Block 16 Section 10

1.0 Context and Character

Diversity and amenity Solar Access

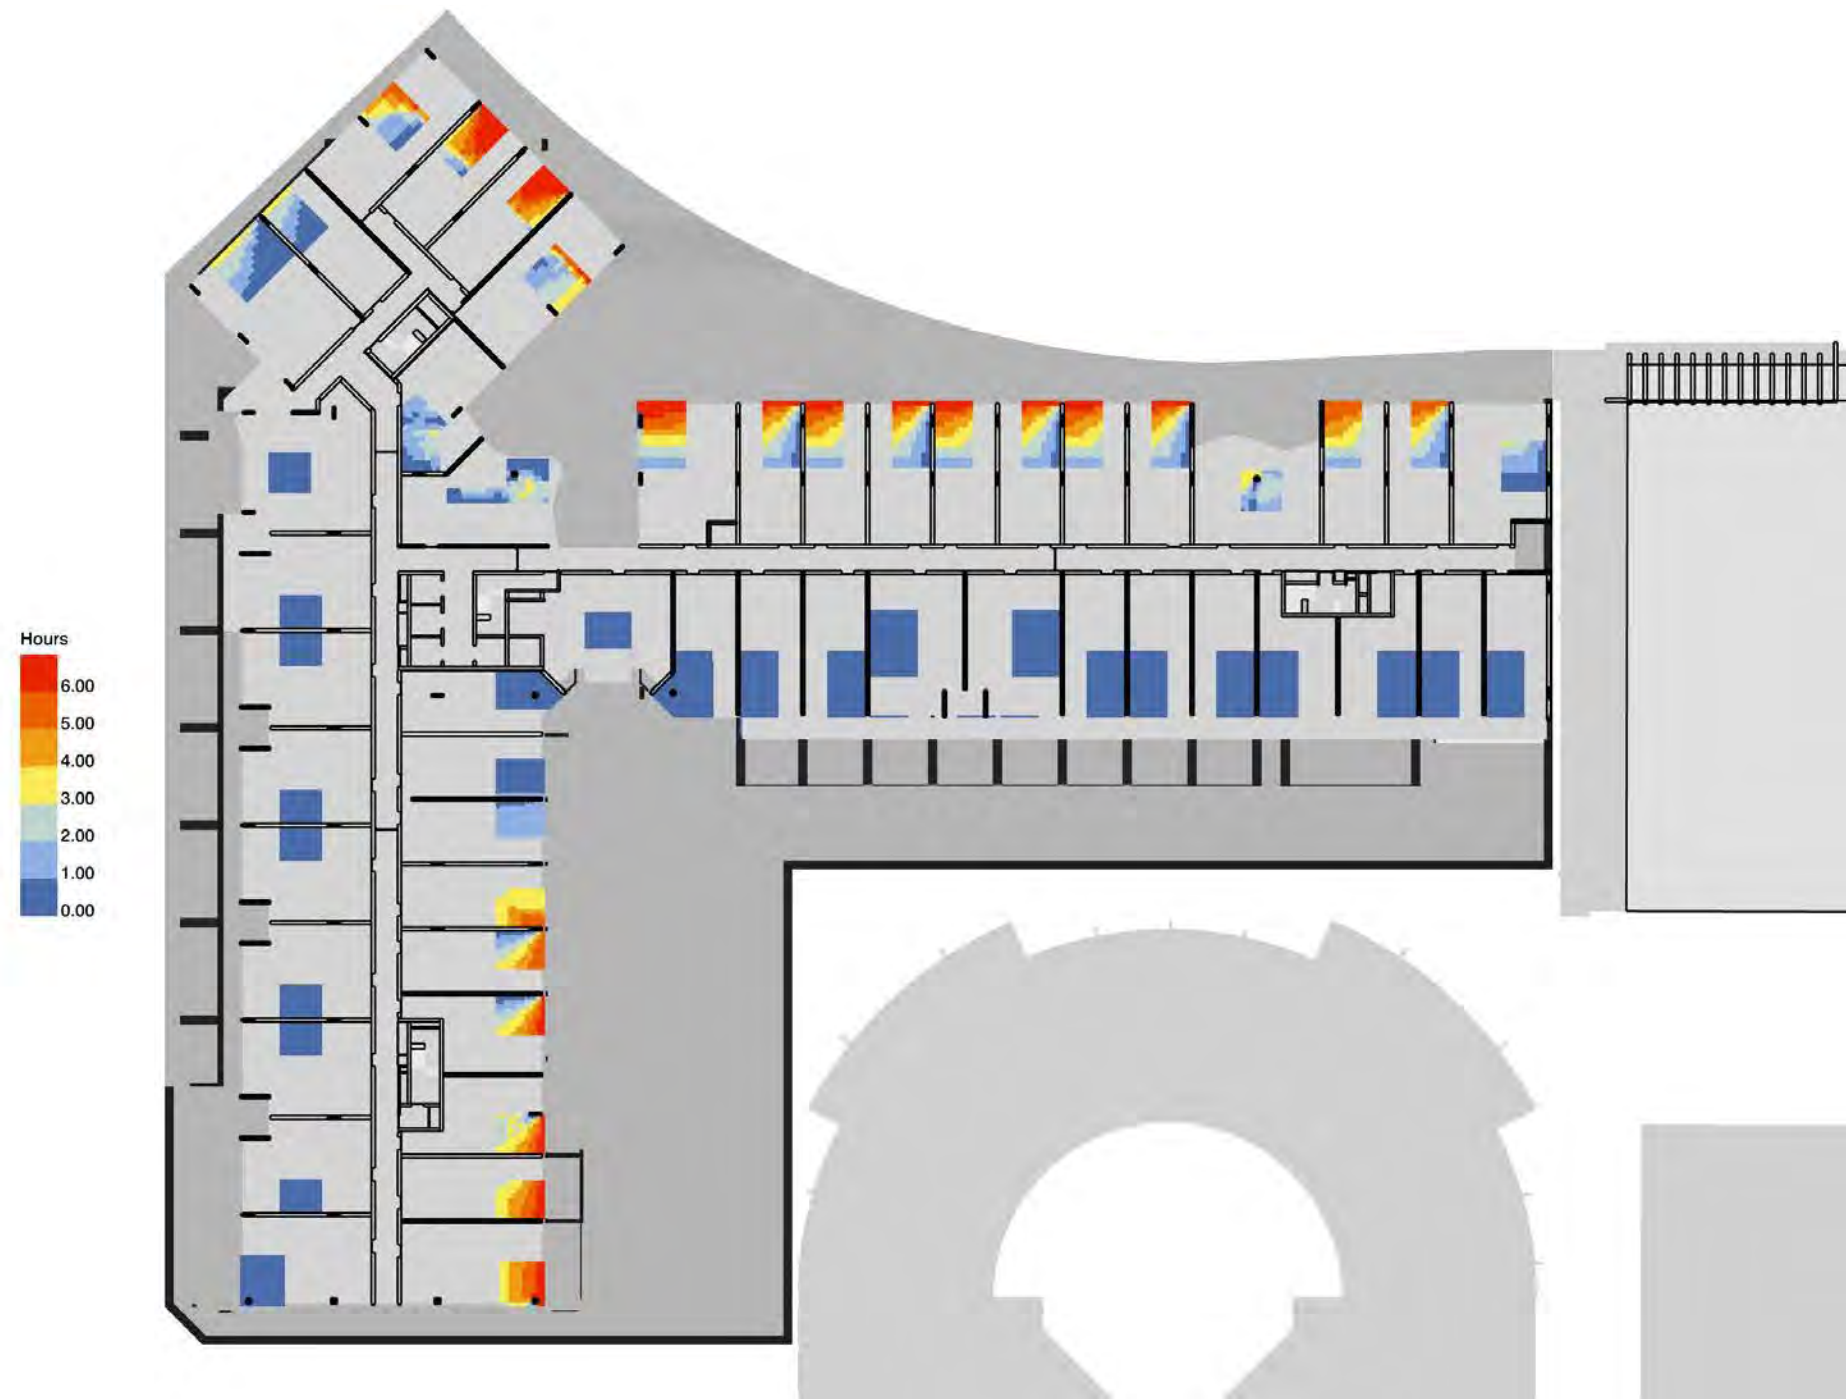
8.1.4 requests demonstration of adequate solar penetration to living rooms to be provided.

Community and public domain Through site connection

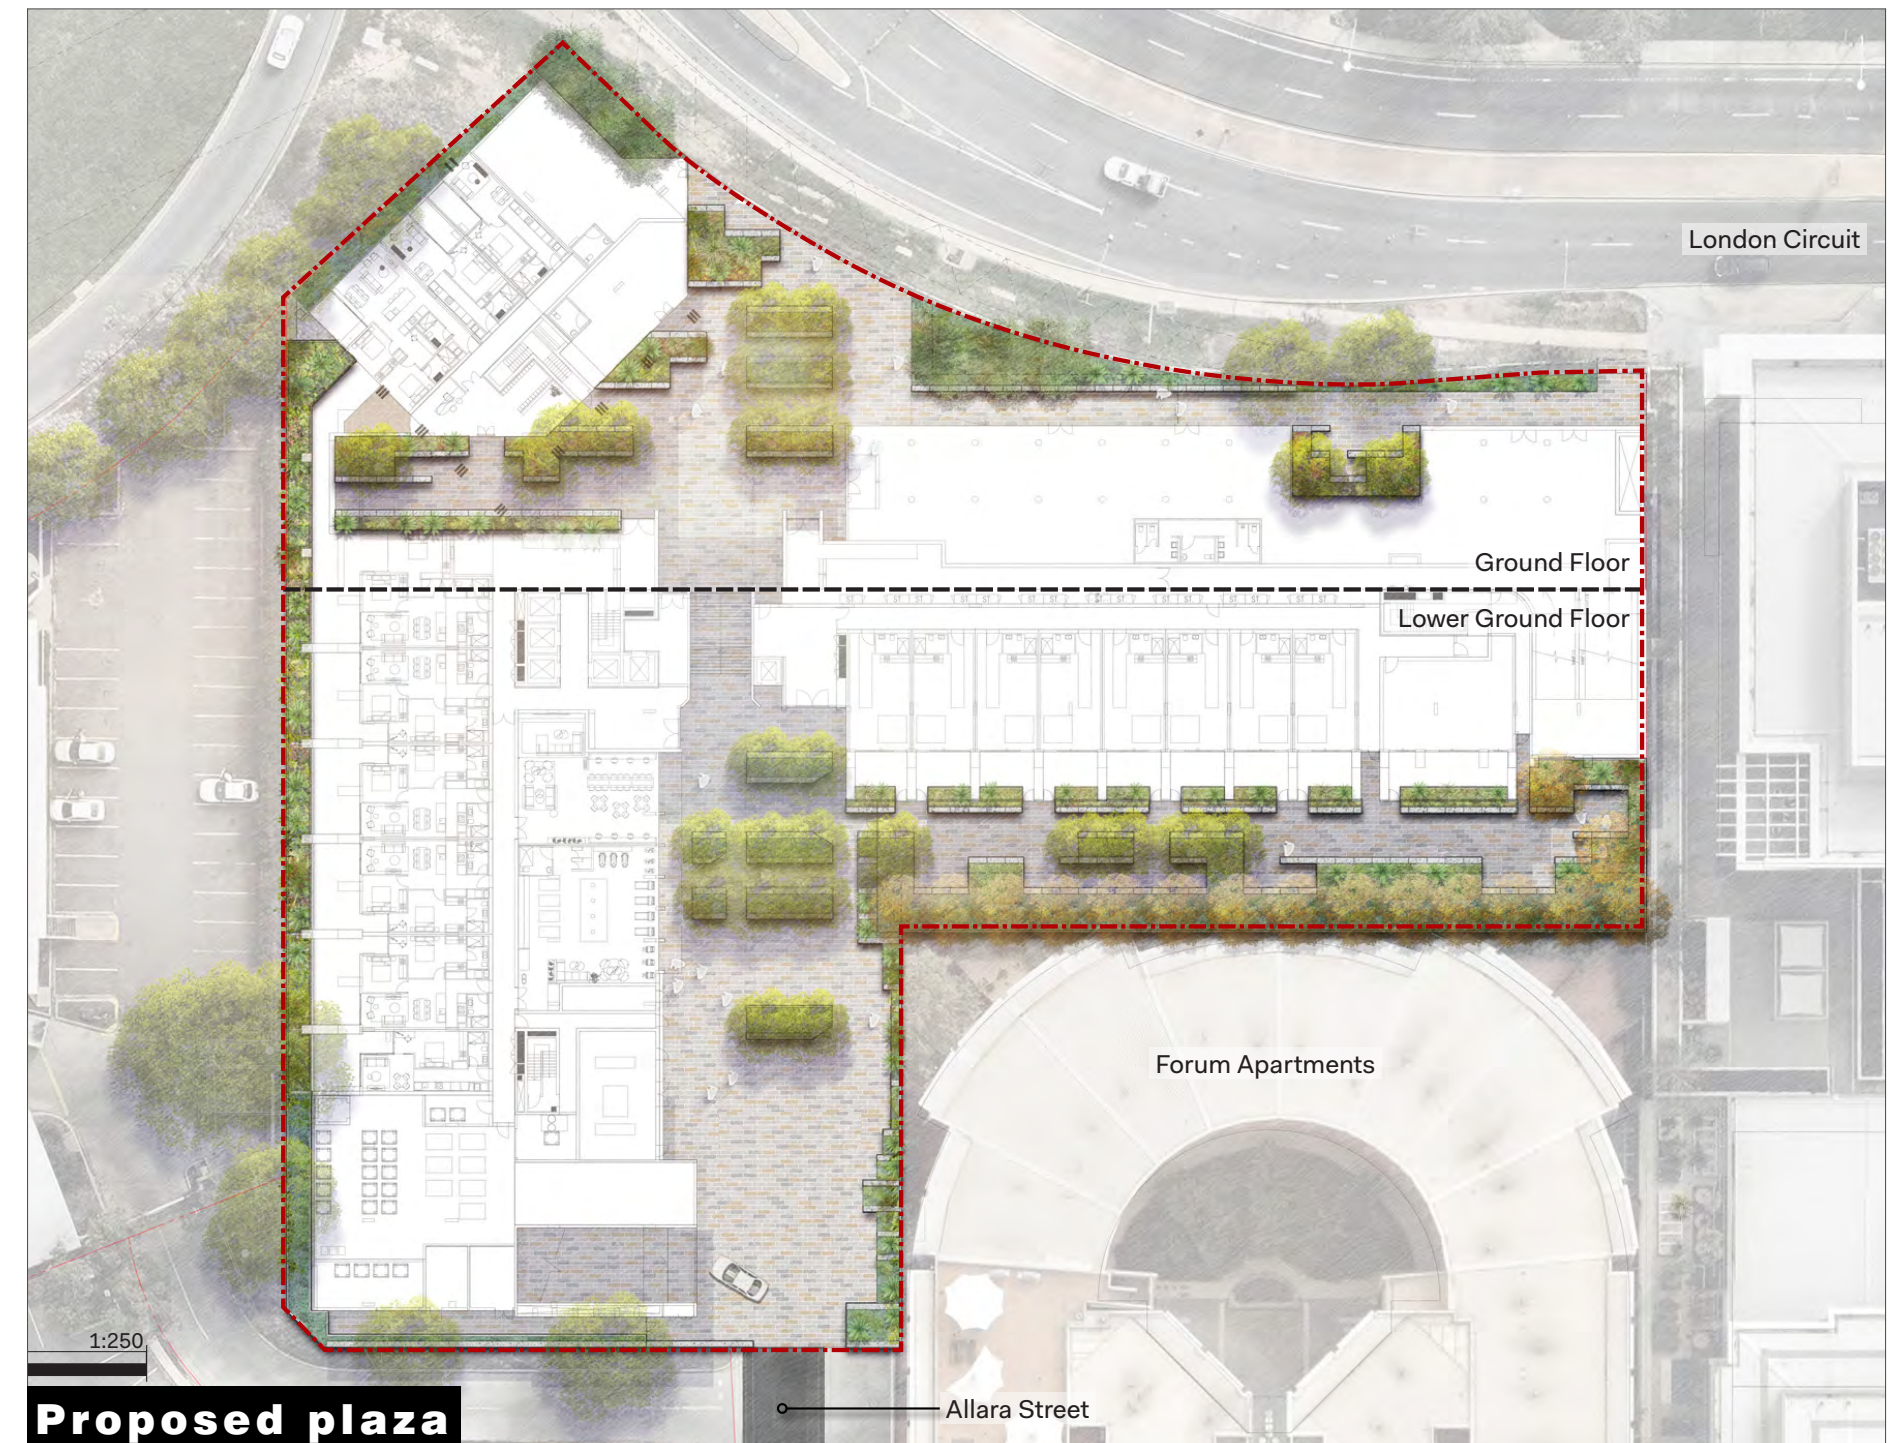
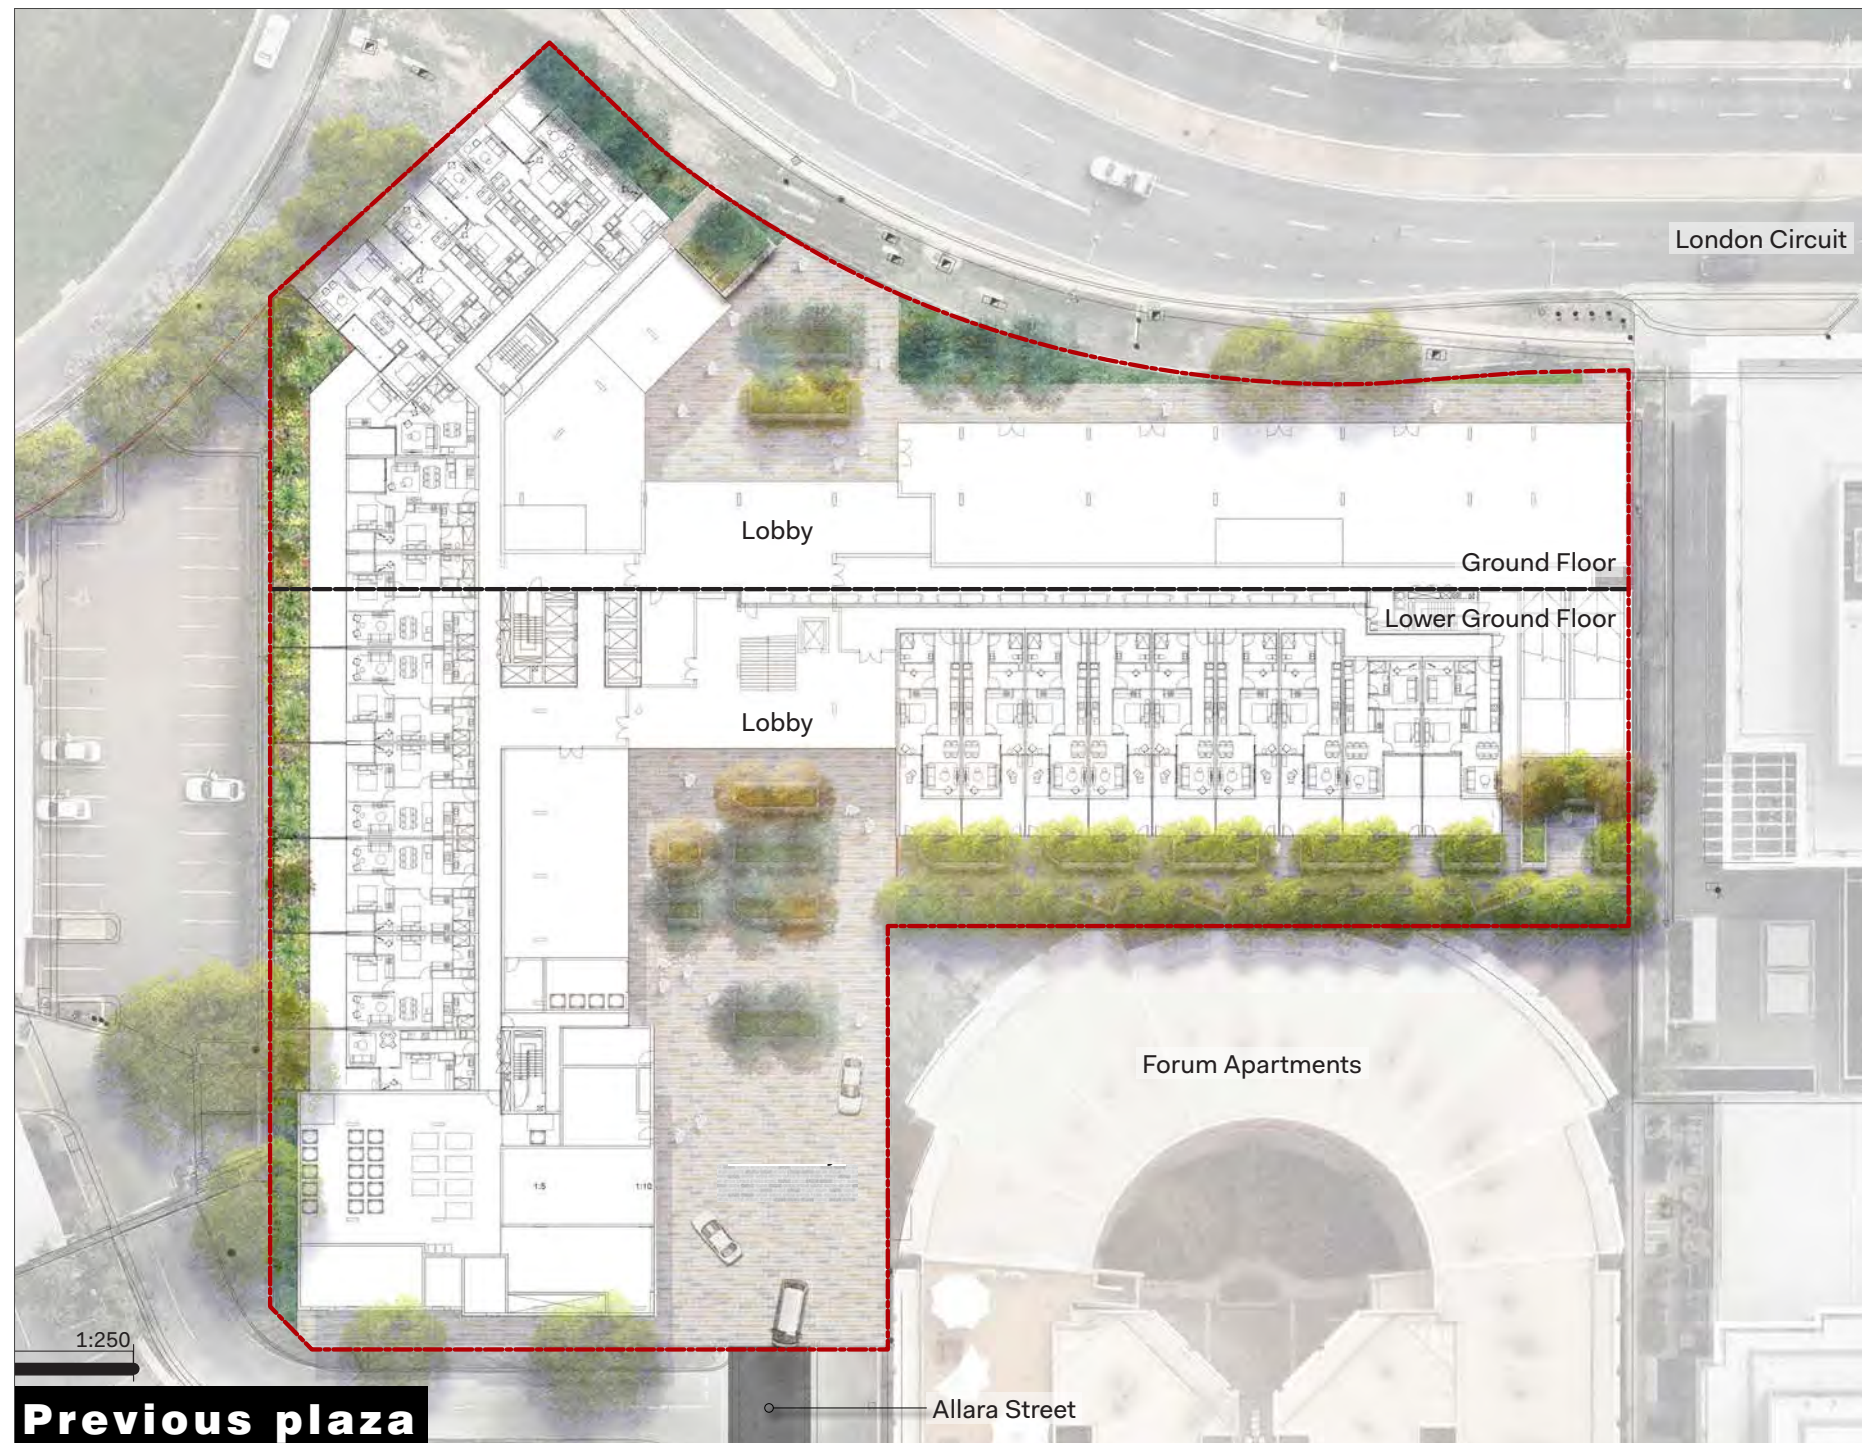
9.1 The Panel continues to support the through-site connection from London Circuit to Allara Street (see 4.1). The Panel, however, considers this link should be open to the sky and that opportunities exist to increase activation and visual permeability of this link as well as provide site permeability at other locations on the site. As such the Panel encourages the proponent team to consider how open access foyers and pedestrian pathways to a variety of destinations may be accommodated in the proposed development to assist activation and community interaction.
